The licensee is authorized to operate the Donald C. Cook Nuclear Plant, Unit No. 1, at steady state reactor core power levels not to exceed 3304 megawatts (thermal).

The Technical Specifications contained in Appendices A and B, as revised through Amendment No. 273, are hereby incorporated in the license. The licensee shall operate the facility in accordance with the Technical Specifications.

FIGURE 3.4-2

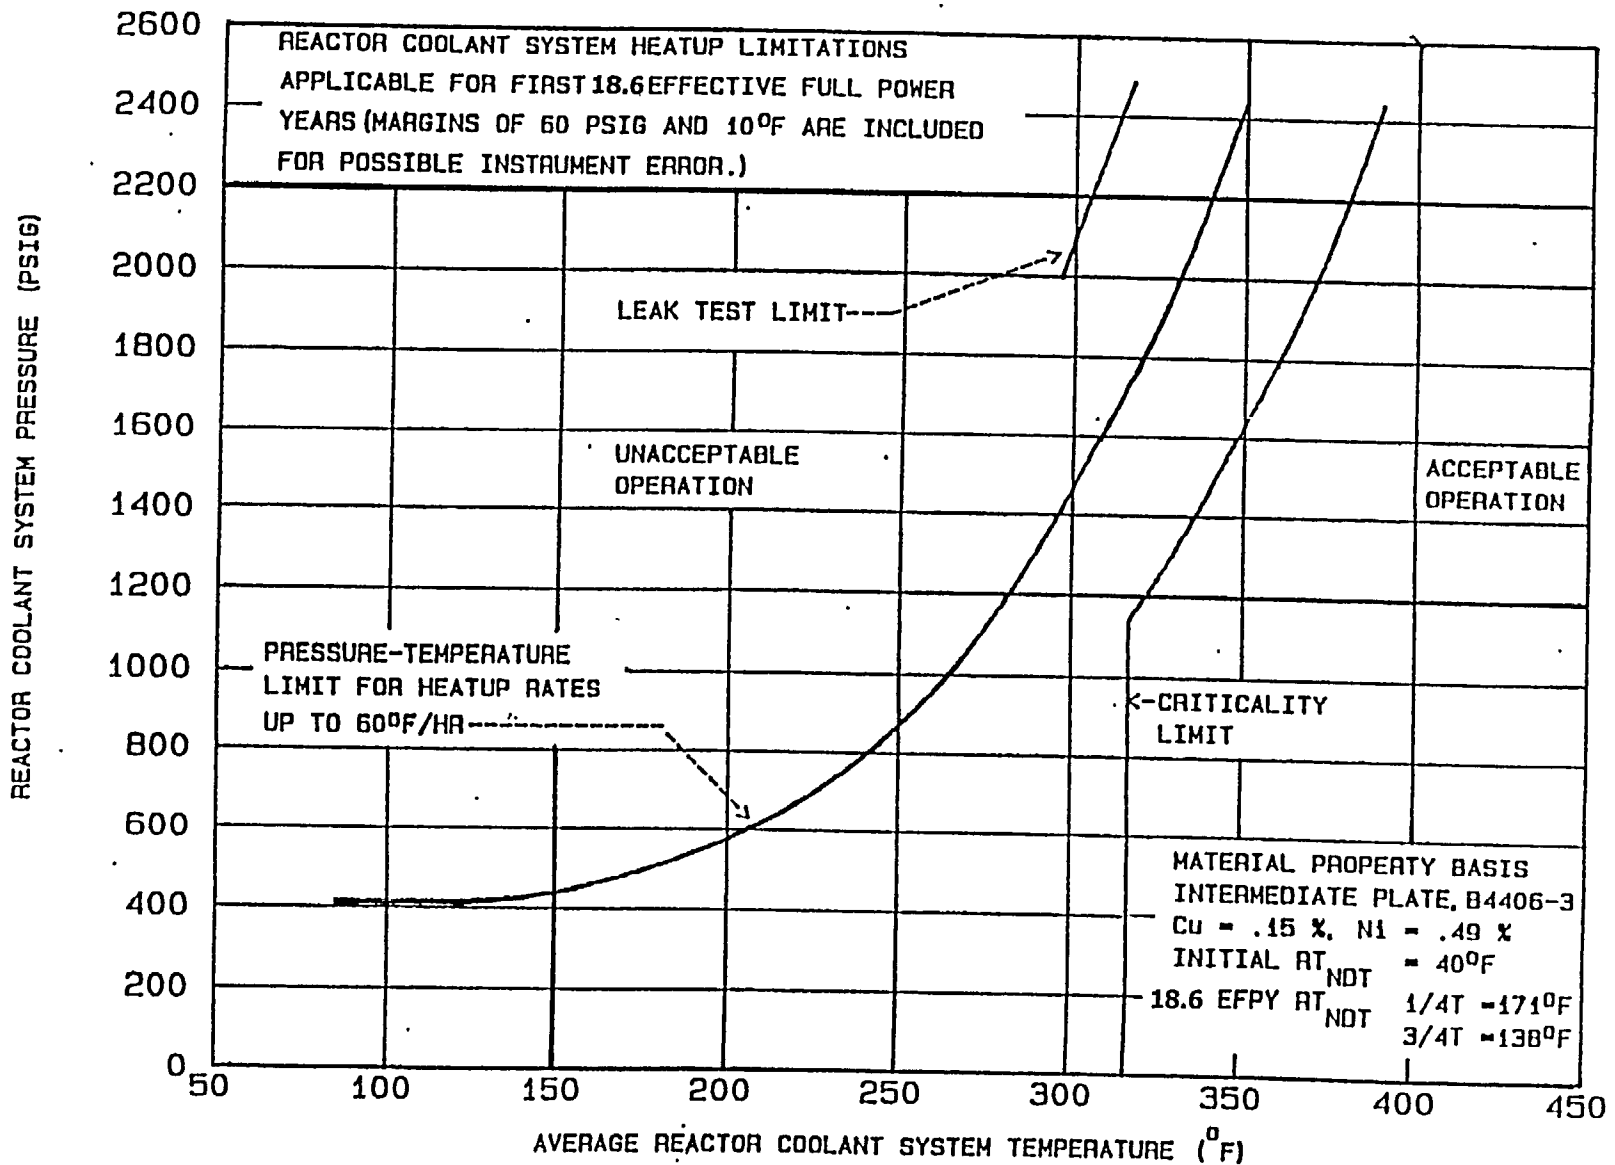
The heatup limit curve, Figure 3.4-2, is a composite curve which was prepared by determining the most conservative case, with either the inside or outside wall controlling, for any heatup rate up to 60°F per hour. The cooldown limit curves of Figure 3.4-3 are composite curves which were prepared based upon the same type analysis with the exception that the controlling location is always the inside wall where the cooldown thermal gradients tend to produce tensile stresses while producing compressive stresses at the outside wall. The heatup and cooldown curves were prepared based upon the most limiting value of the predicted adjusted reference temperature at the end of 18.6 EFPY.

Reactor operation and resultant fast neutron ( $E > 1$  Mev) irradiation will cause an increase in the  $RT_{NDT}$ . Therefore, an adjusted reference temperature, based upon the fluence, and the copper and nickel content of the material must be predicted. The heatup and cooldown limit curves of Figures 3.4-2 and 3.4-3 include the adjusted  $RT_{NDT}$  at the end of 18.6 EFPY, as well as adjustments for possible errors in the pressure and temperature sensing instruments.

The pressure-temperature limit lines shown on Figure 3.4-2 for reactor criticality and for inservice leak and hydrostatic testing have been provided to assure compliance with the minimum temperature requirements of Appendix G to 10 CFR 50.

The 18.6 EFPY heatup and cooldown curves were developed based on the following:

1. The intermediate shell plate, B4406-3, being the limiting material with a copper and nickel content of .15% and .49%, respectively.
2. The fluence values documented in I&M letter AEP:NRC:2900-02.
3. Figure 1, NRC Regulatory Guide 1.99, Revision 2
